CITY of NOVI CITY COUNCIL

Agenda Item 4
May 23, 2016

SUBJECT: Consideration of a request from Neptune Center for a variance from Section 11-239(b) of the Design and Construction Standards of the City Code, which requires parking areas and maneuvering lanes to be hard-surfaced and curbed, to allow the applicant to construct a parking area that has no curb on parcel number 22-15-451-009.

JSP14-10 Neptune Center

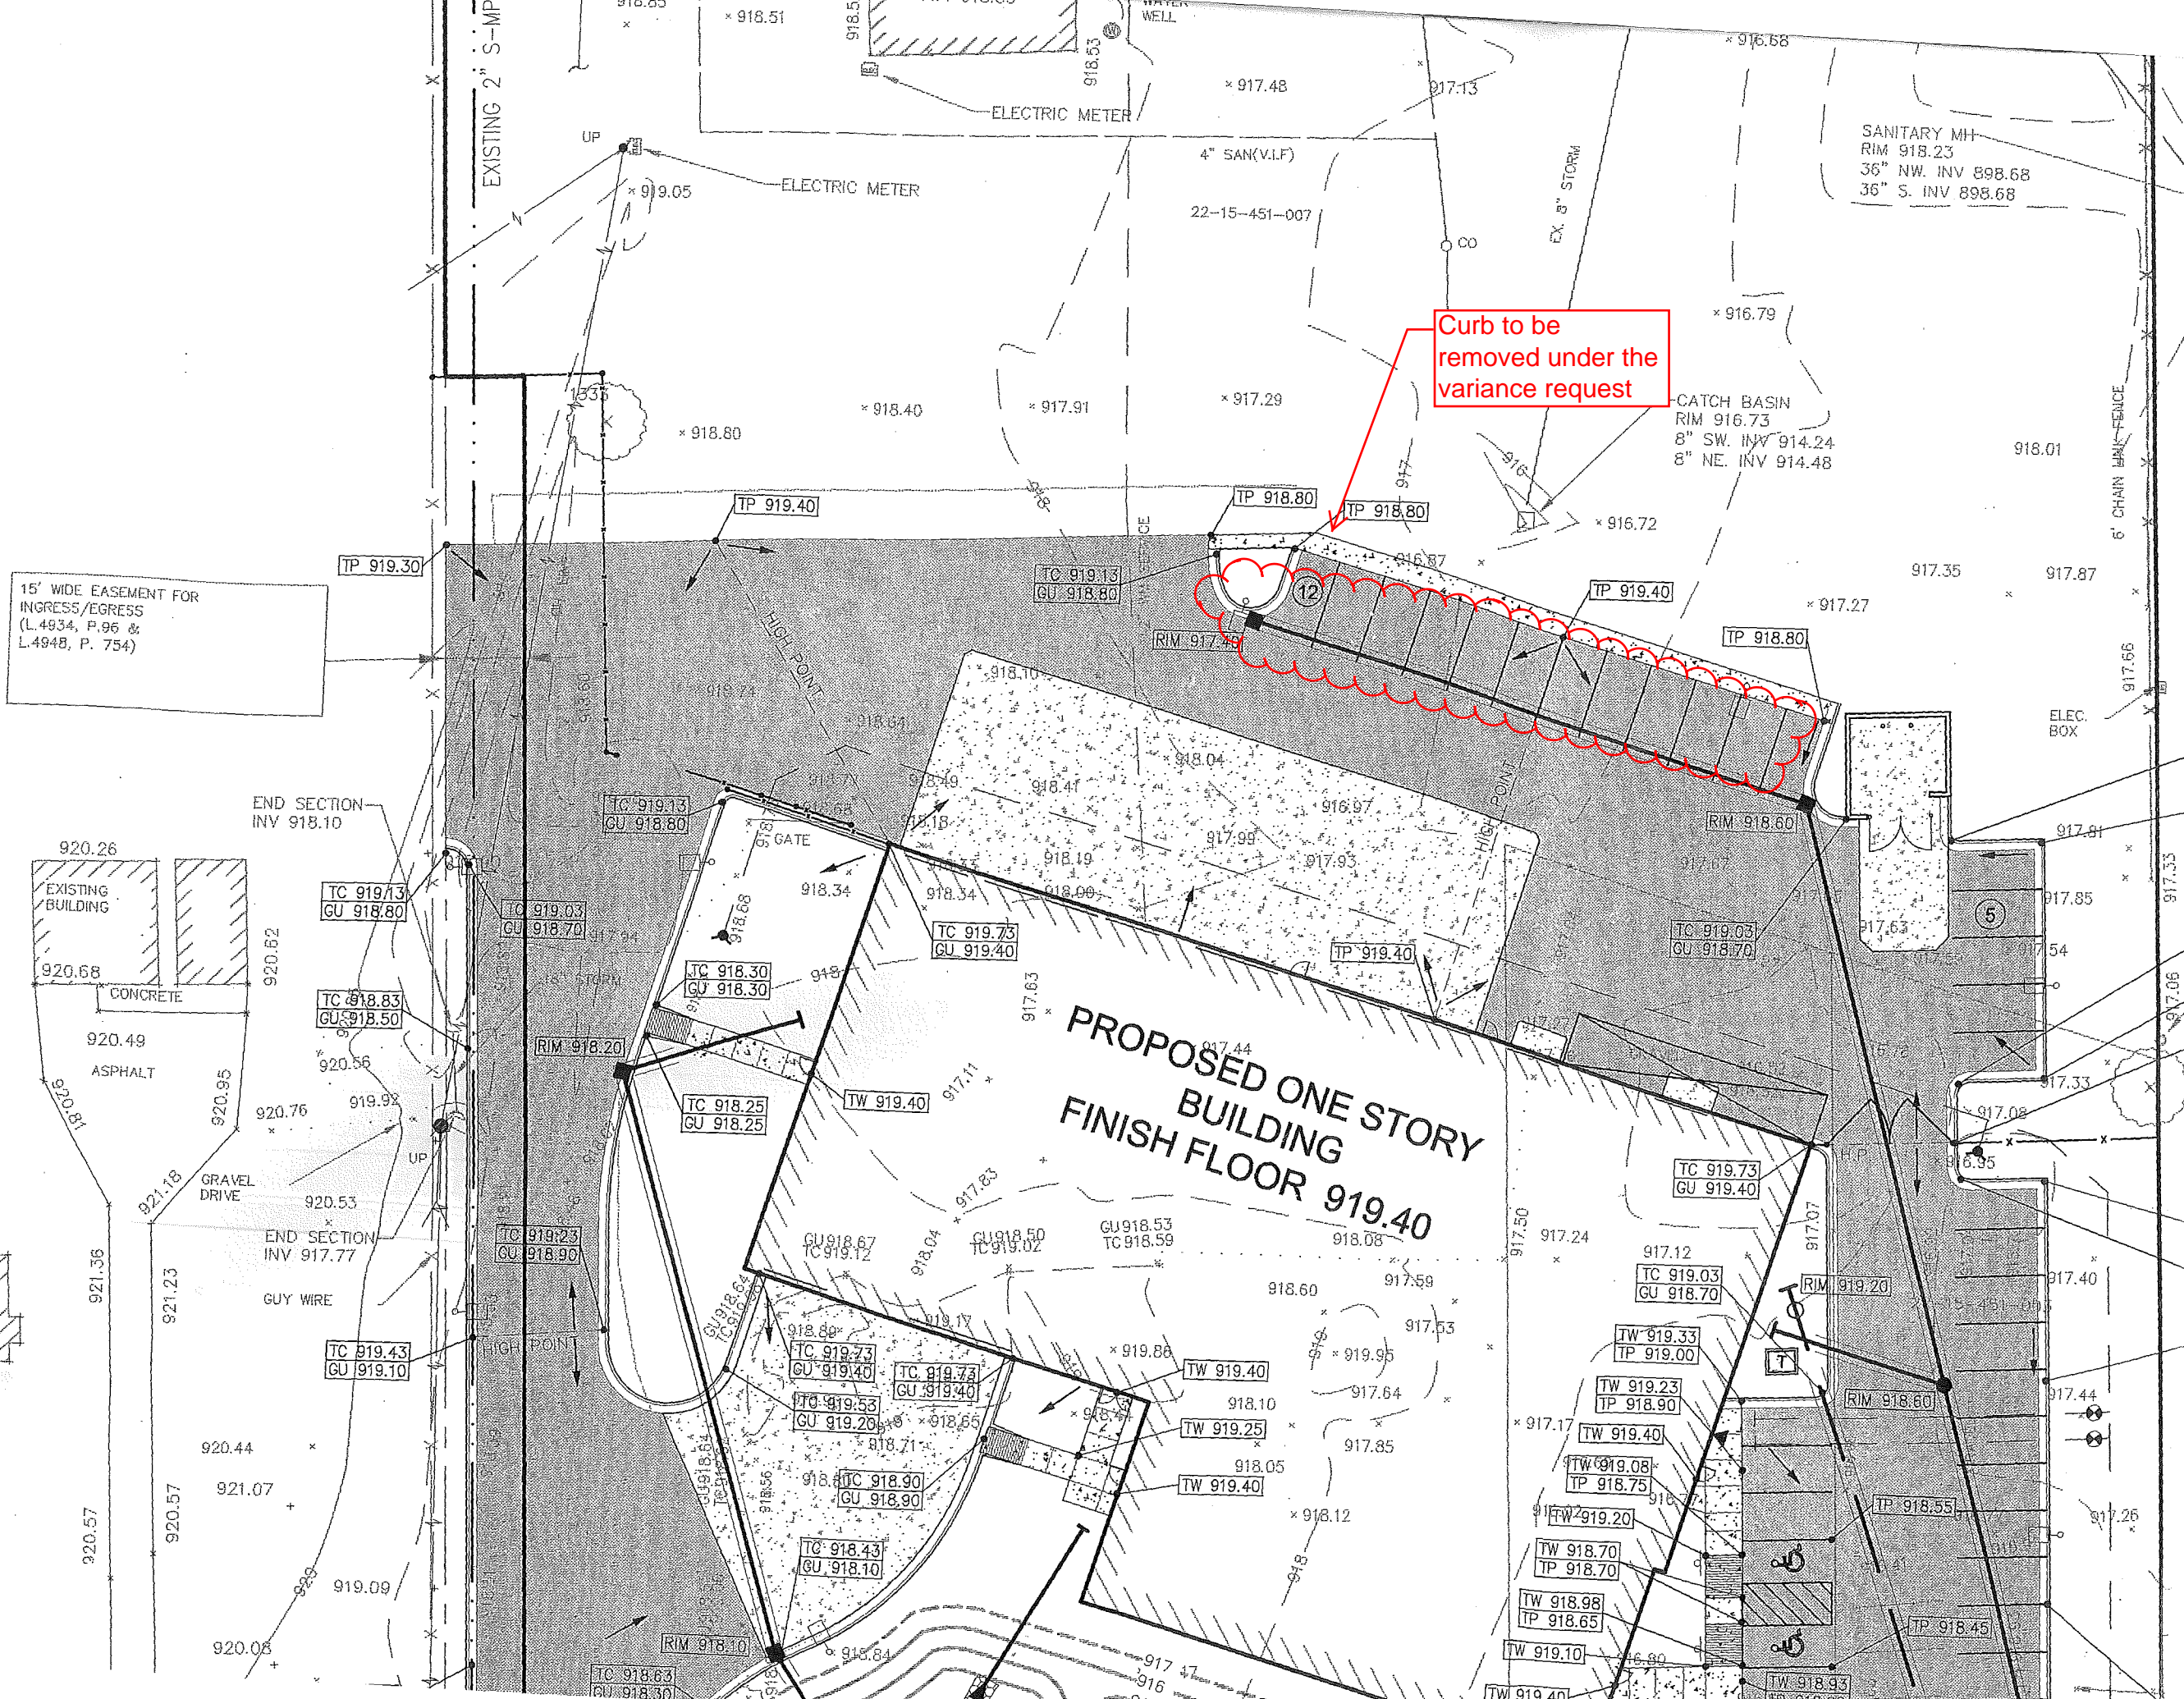
The approved site plan included a concrete curb and sidewalk along the north side of the new asphalt parking area behind the newly constructed building which separates the new asphalt parking from the old gravel area behind the new building (see attached plan). As the project is nearing completion, the applicant is requesting a variance to relieve the requirement for curb (and sidewalk) along the north side of the new asphalt parking area. The variance would permit unimpeded access between the new parking area and the existing gravel area as shown in the attached photos. (The curb is an ordinance requirement, thus the subject of the variance, while the adjacent sidewalk is a site plan requirement and would require a revised final site plan).

The applicant has submitted a Design and Construction Standards Variance Request to not construct the curb as described above (see attached application). The applicant claims that required curb "becomes an obstacle to the truck movement into the building from the north." The presence of vehicles parked in the newly constructed parking area should also pose an obstacle, however the applicant states that since those spaces are for employees "management of those spaces is easily controlled by the general manager when the need for straight truck access is required." These operational concerns should have been addressed during the site plan review of the project. In one discussion with the applicant, the applicant indicated to staff that the curb was shown on the plan only to get site plan approval without the intent to ever construct it. This statement conflicts with the operational issues identified in the application.

Curb to be removed under the variance request

Community Development and DPS Engineering are recommending *denial* of the variance for the following reasons:

- Curb and gutter serves a drainage purpose to guide and direct the flow of storm water within the parking area to the storm water collection system for treatment and storage prior to discharge and protects the edge of the parking lot from erosion.

- The granting of the variance would be detrimental to the public health and welfare because the proposed alternative increases the concern for erosion of material from the site, as well as for transport and deposition of suspended solids into the adjacent wetlands and possibly onto adjacent properties. The applicant has not provided any data or information to refute this claim; therefore, staff believes that there is a risk of injury to the wetland and the adjacent property owners.

TITLE
 Paving - Grading Plan

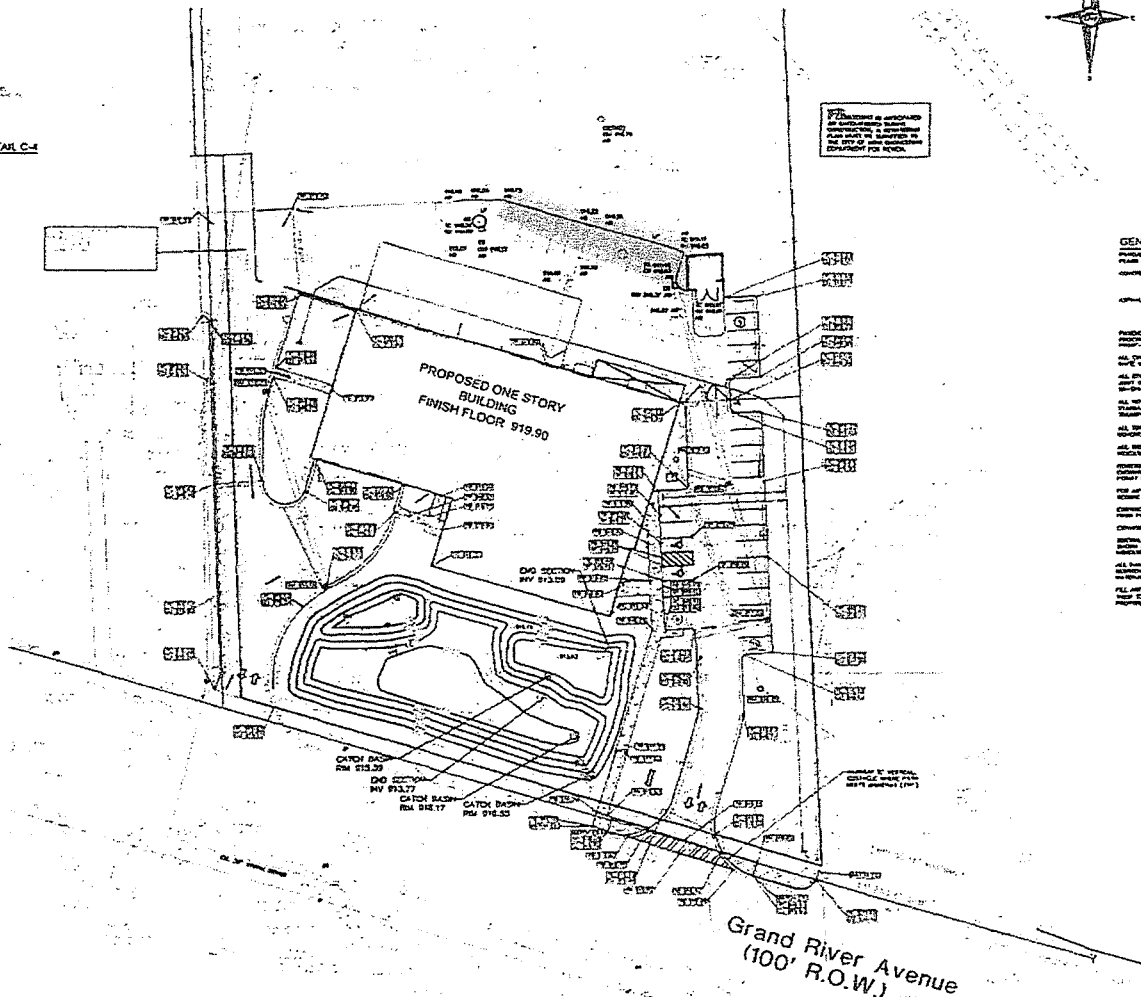
The challenge being that in many instances, it is necessary to drive the trucks “straight” into the storage and service doors on the north side of the building from the northerly portion of the property, north of the concrete curb at the 12 parking spaces. The Novi Design and Construction Standards require a concrete curb at the edge of the parking spaces and this becomes an obstacle to the truck movement into the building from the north only. It is important to note that in all other areas of the parking lot and drive approaches, the development meets the requirements of Section 11-239(b). Also, the area of parking in question north of the building is for employees; management of those spaces is easily controlled by the general manager when the need for straight in truck access is required. Thus, Neptune Development is requesting relief, or variance, from the concrete curbing requirement as described.

The proposed alternative of eliminating the curb and maintaining proper pavement drainage to the south demonstrates satisfactory performance – see attached Grading Plan. The northerly portion of the property adjacent to the parking asphalt pavement will be flush with the asphalt for the occasional truck traffic use for straight in access to the service and storage doors of the building.

The elimination of the required concrete curb north of the 12 parking spaces on the north side of the building will in no way compromise the public health, safety or welfare, nor be injurious to adjoining or neighboring properties. The area in question is not adjacent to any property lines, will be utilized by employees only and is not visible from Grand River. In addition, this service business rarely has outside visitors and in the event that visitors should arrive onsite, the parking to the east of the building completely conforms to the Code section in question.
